Re: Objection to Planning Application HGY/2026/1046 — 11 Berkeley Road, Haringey, N8 8RU

This document forms our objection to the current planning application HGY/2026/1046 - 11 Berkeley Rd, N8 8RU.

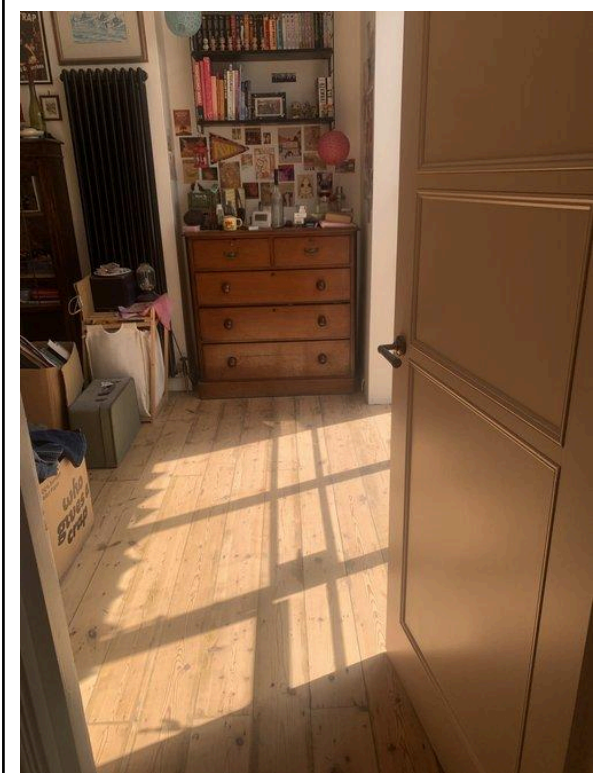
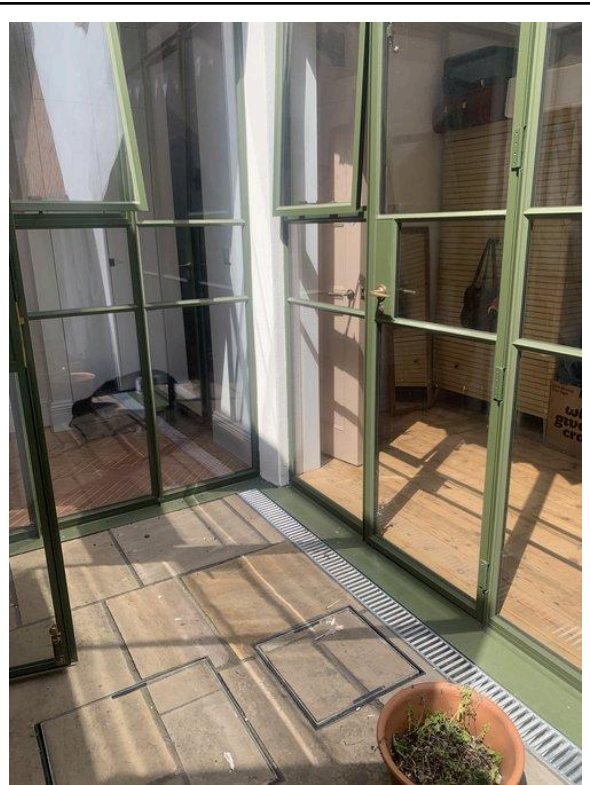
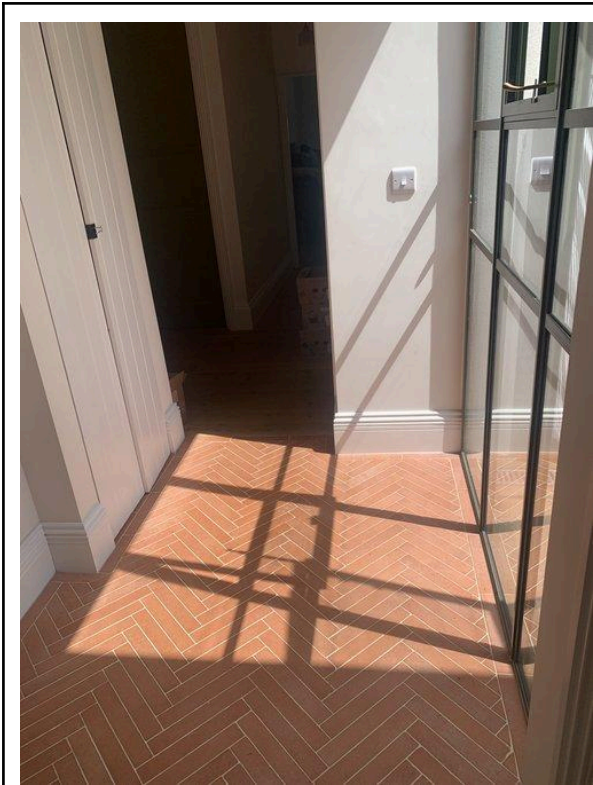
"The courtyard receives only around 3 hours of light on 21 June, as existing."

This is untrue. It is the officer's own arithmetic, not ours — 21 hours of a 24-hour cycle leaves 3 — and our own independently verified modelling, cross-checked against dated, timestamped photographs, directly contradicts it: bedroom 2's window alone — the room for which this courtyard is its only source of daylight — receives close to 6 hours of direct sunlight on that date, already exceeding the officer's figure for the courtyard as a whole, before any account is taken of light reflected from the courtyard's pale render.

Below are a selection of photos showing direct sunlight reaching the courtyard and surrounding rooms at intervals across the day in mid July 2026, from 10am through to 3.30pm. This is 3-4 weeks after 21 June.

Seasonal sun angles at solar noon, overlaid on the applicant's own submitted rear elevation drawing, measured from the ante room window position. A conceptual illustration only, not a precise technical drawing — see note on the image itself.

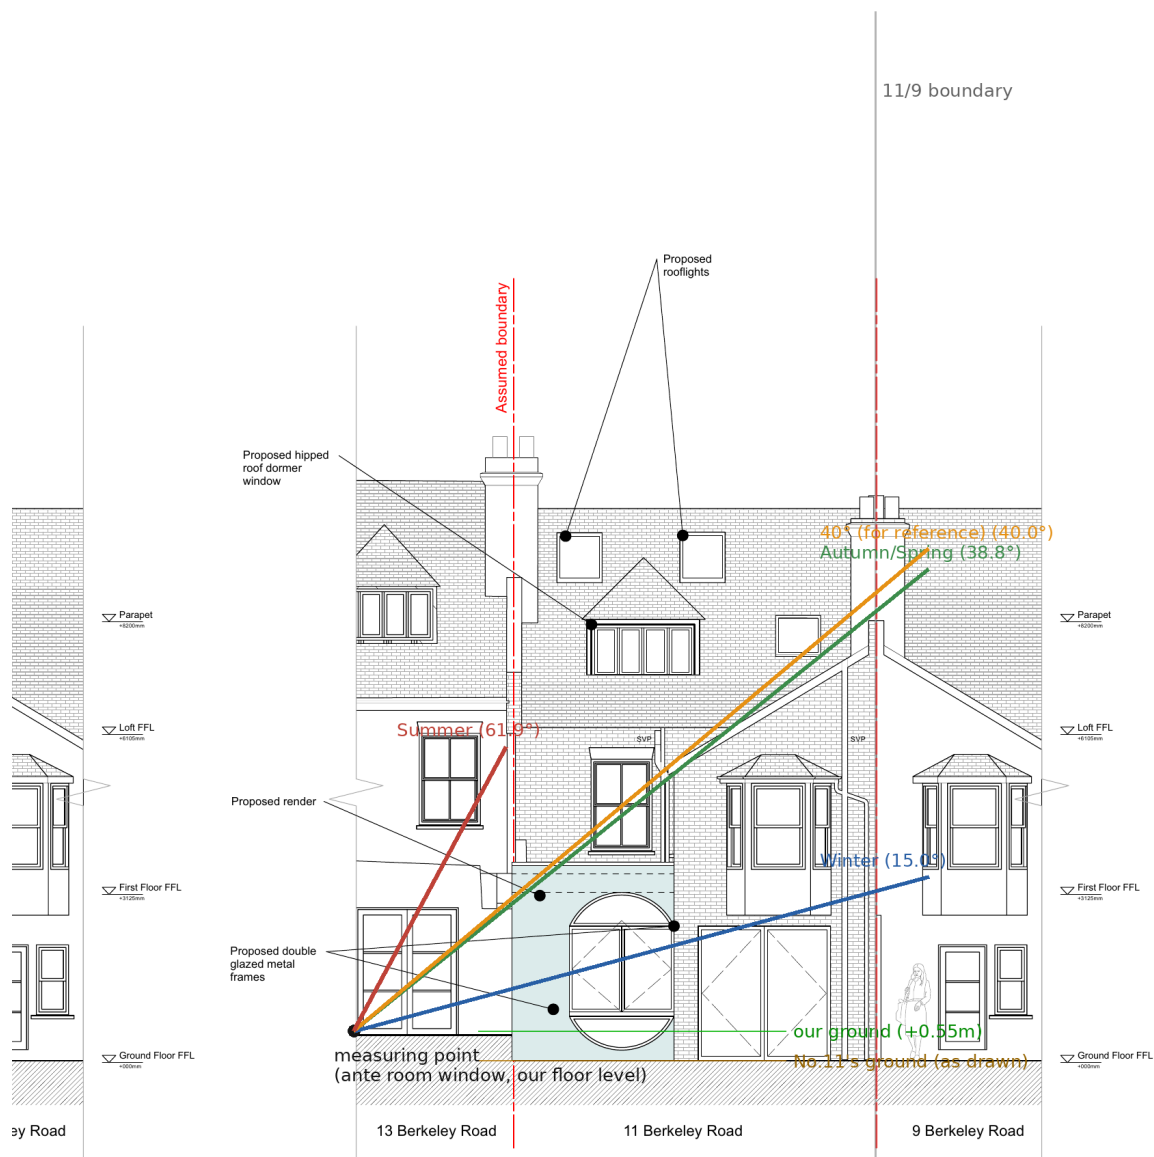
The diagram below overlays the sun's seasonal altitude at solar noon — winter, spring/autumn, and summer, plus a marginal 40° reference line — directly onto the applicant's own submitted rear elevation, measured from the ante room window position. It is a conceptual illustration only, not a precise technical drawing, but it shows plainly why a sloped roofline lets more of this light through to the courtyard than a uniformly tall flat one: a flat structure held at a height sufficient to block the low winter and equinox sun blocks it at every point along its depth, while a sloped profile, low at the boundary and rising only gradually, is clear of that same sun path for most of its length.

This diagram makes two points that are easy to miss in the tables alone. First, it shows what is actually doing the blocking. On days and times when the sun sits high enough to clear the far, existing outrigger structure altogether, it demonstrates that it is the proposed structure's own height at the boundary — not anything already there — that stops that light reaching the courtyard. The obstruction this objection is about is the new one, not the old one.

Second, it shows why a single test date can understate the real impact. The additional 40° reference line, barely above the equinox angle of 38.8°, illustrates how marginal that specific test point is: a difference of little more than a degree is enough to decide whether the

boundary is cleared at all on 21 March, the date BRE guidance and the Council's own assessment rely on. Tested at exactly that angle, the difference between existing and proposed can look small or absent, not because the impact is not real, but because that single date happens to sit right on this knife-edge. The winter-total and 21 March figures set out earlier in this letter, which test across a full period rather than one moment, are what actually capture the loss this diagram illustrates.

The remedy is straightforward, and we set it out in full below. The proposed solution, as suggested in our original comments on the first round of submissions, is to constrain the boundary wall to 2.3m, in line with existing precedents³, and to adjust the roof profile to a sloped design down towards the boundary from a max height of 3.5m. This represents an
